Apache Corporation would like to request a variance from the approved interim reclamation. The approved IR Plat suggested that the location was to built at 270x225, remove 70' from the north of the pad and 70' from the east of the pad. Based on the placement of the wellbore and the location being built as 274 x 221, with misplaced lines on the east side as well as the two protrusions, we would like to suggest the following:

**APACHE TONY
FEDERAL #037**

INTERIM RECLAMATION LAYOUT

Proposed Pad Measurements

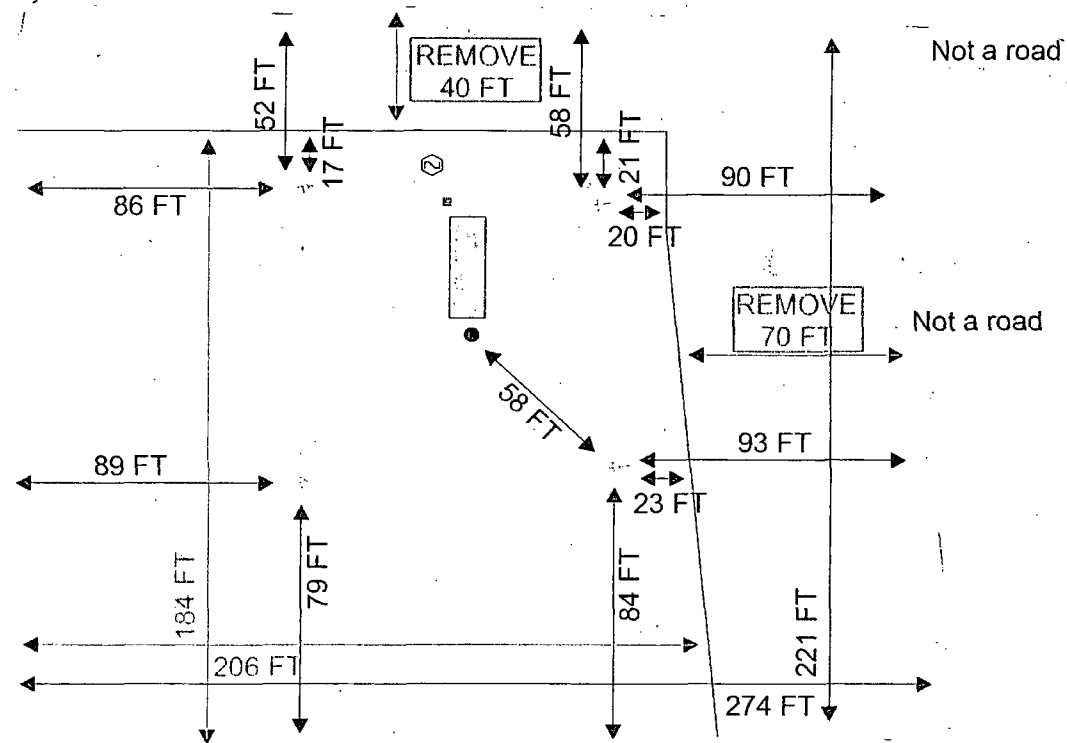
Removing 40' from the north which would leave us 17' from the anchors and removing 70' plus the two protrusions leaving 20' from the anchors. The south and west side of the location will need to remain as is for production operating usage.

The former pad measured 221 FT x 274 FT,

The downsized pad measures 184 FT x 206 FT.

Pad Measurements

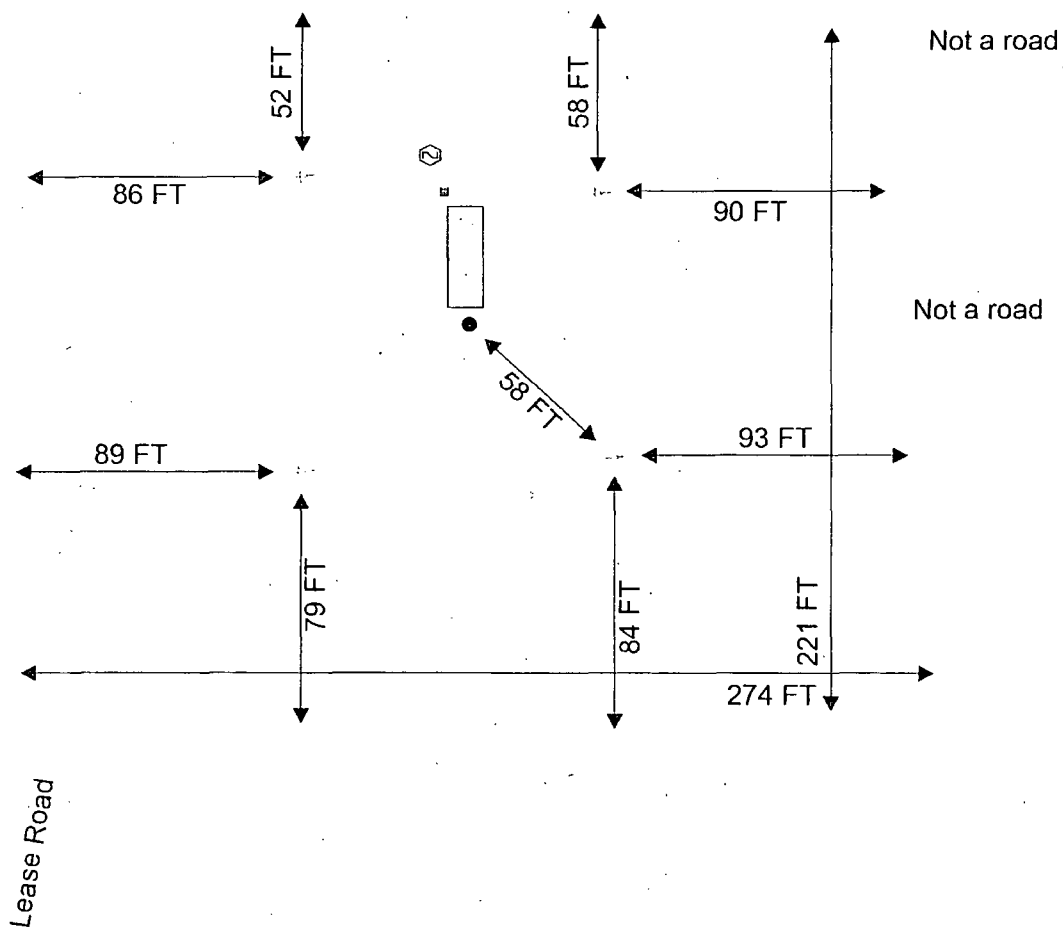
The frac tank is located 106 ft E and then 41 ft south of the well head.
